Nº 149 SERVICE BULLETIN

SUBJ: Potential Ball Trap by the Upper Left Pop Bumper (ask your Distributor for SPI Kit Nr. 502-5025-81)

Flat Rail (Ball Guide) Extension Installation

SPI Kit Nr.: 502-5025-81

Figure 1

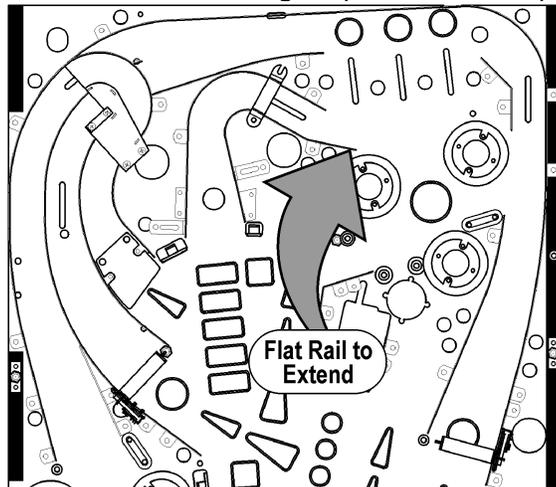
A Pinball gets trapped behind/under the **Upper Left Pop Bumper Cap** (next to Plastic Ramp). See Fig. 1 below.

Get the Flat Rail (Ball Guide) Extension Installation SPI Kit, 502-5025-81 and install the Flat Rail (Ball Guide) Extension, 535-9468-00 (see Fig. B, next page). This kit includes a detailed step-by-step procedure with photos, a copy of this Service Bulletin and the new Add-On Extension Flat Rail and Securing Hardware.

**ORIGINAL FLAT RAIL
REQUIRING ADD-ON
RAIL FIX ∴ 3/16" to 3/8"**

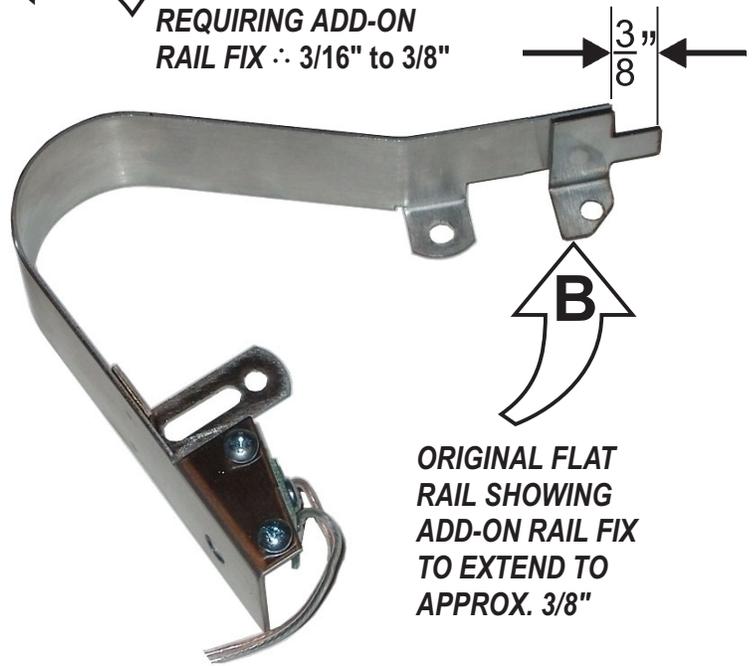
Early production games had a Flat Rail, 535-9327-00 (Item 35, Page 64 of your Ripley's Service Game Manual) which did not extend out far enough to prevent a ball trap; if the extension measures approximately **3/8"**, **this fix is not required** (see Fig. C & D, next page). The next page depicts the old, modified and new rails so you can determine if your game requires this installation. **ONLY** Games with the extension measuring approximately **3/16"** would require this fix (see Fig. A, next page).

**ORIGINAL FLAT
RAIL SHOWING
ADD-ON RAIL FIX
TO EXTEND TO
APPROX. 3/8"**

**FLAT RAIL WITH A
WELDED EXTENSION
(DOES NOT REQUIRE
THE ADD-ON EXTENSION)**

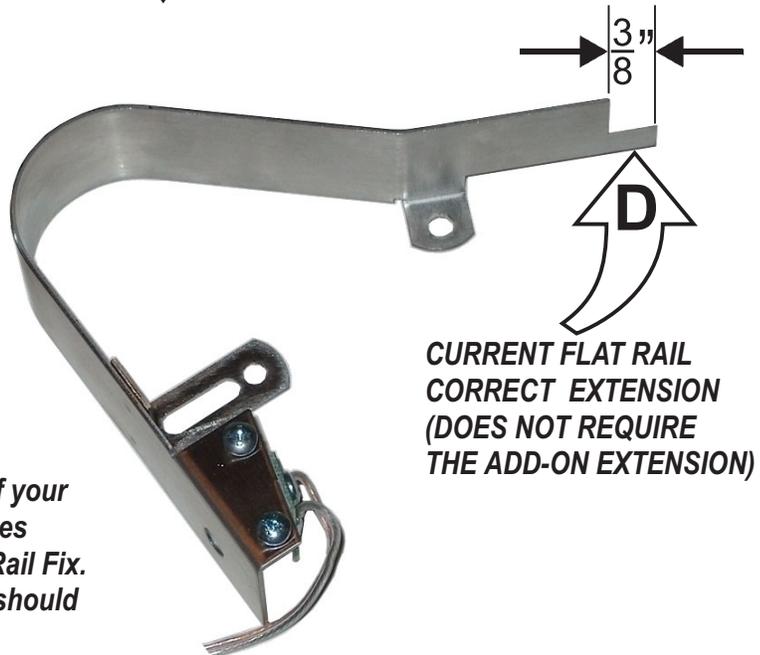
IF YOUR FLAT RAIL (535-9327-00, Item 35, Page 64 of your Game Manual) looks like either of the bottom examples (C or D), you do not require the Add-On Extension Rail Fix. Note the extended tab length (by Pop Bumper Ring) should be approximately 3/8" long.

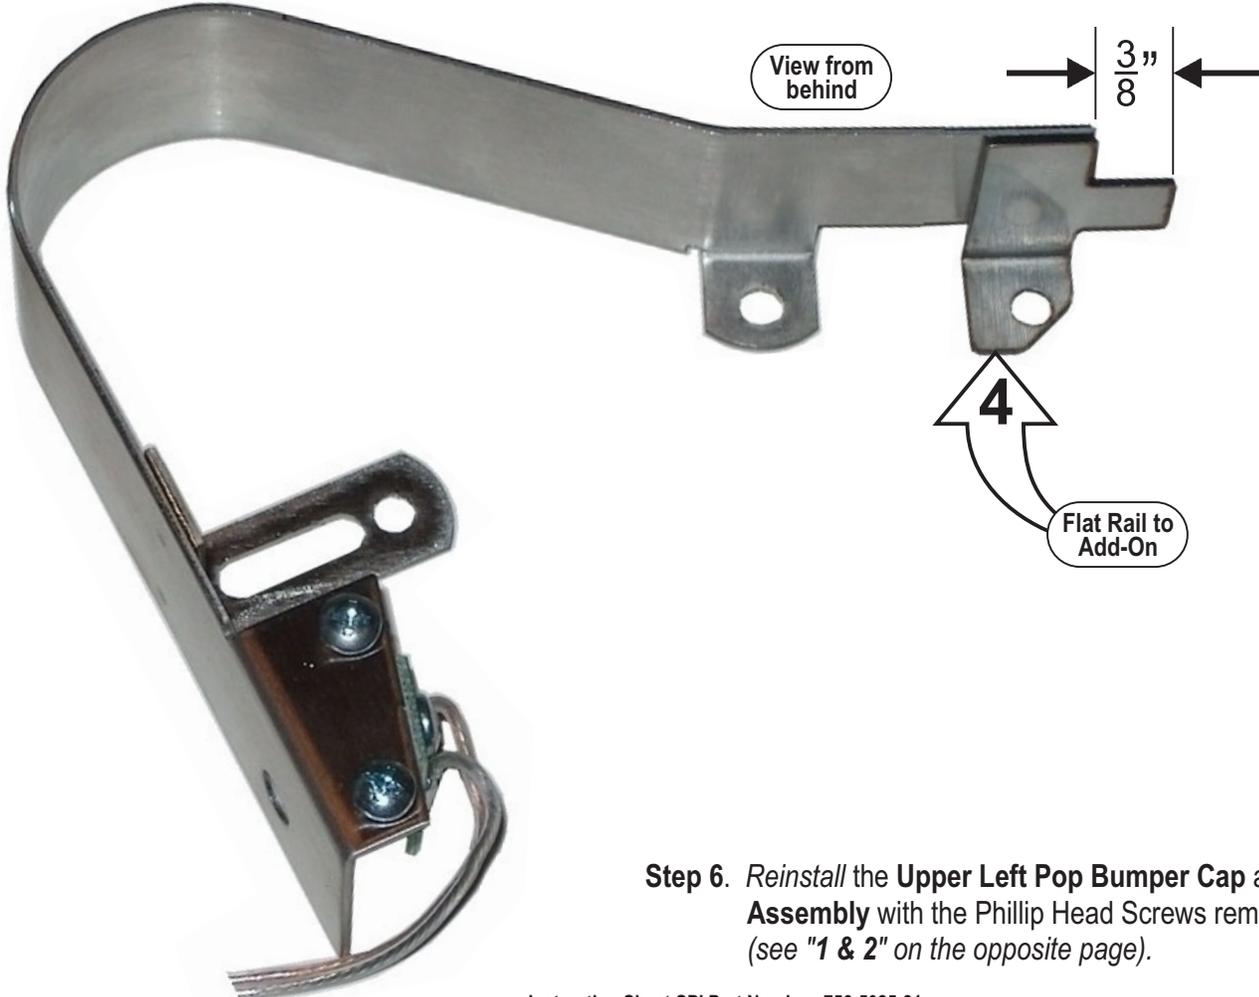
Step 4. Position the new **Flat Rail (Ball Guide) Extension** (535-9468-00) behind the **Flat Rail** (see "4" below).

Step 5. Fasten the new **Flat Rail Extension** to the playfield with the enclosed **#8 X 1/2" HWH Screw** (see "5" above).
